RESPONSE TO SITE SPECIFIC ADVISORY BOARD RECOMMENDATION ON THE FACT SHEET FOR THE EXPLANATION OF SIGNIFICANT DIFFERENCE FOR THE MOLTEN SALT REACTOR EXPERIMENT RECORD OF DECISION AT THE DEPARTMENT OF ENERGY OAK RIDGE RESERVATION

Making a Change to the MSRE Record of Decision

Record of Decision for Interim Action to Remove Fuel and Flush Salts from the Molten Salt Reactor Experiment Facility at the Oak Ridge National Laboratory, Oak Ridge, Tennessee (DOE/OR/02-1671&D2)

Fig. 1. Graphic comparison of approved ROD and ESD remedies.

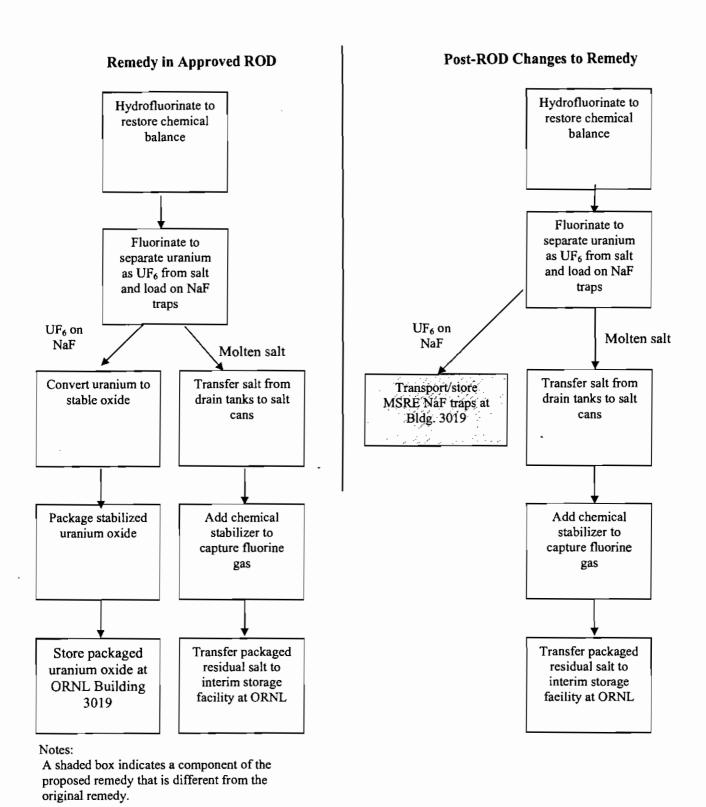
This post-ROD change impacts the scope and cost of the MSRE remedy. A side-by-side comparison of the original and proposed remedy components is given in Fig. 1 to clearly display the significant differences with regard to scope. A shaded box indicates a component of the proposed remedy that is different from the original remedy.

The original and proposed remedy components differ only after the point in the process where the uranium has been separated from the salt by fluorination and then collected on NaF traps.
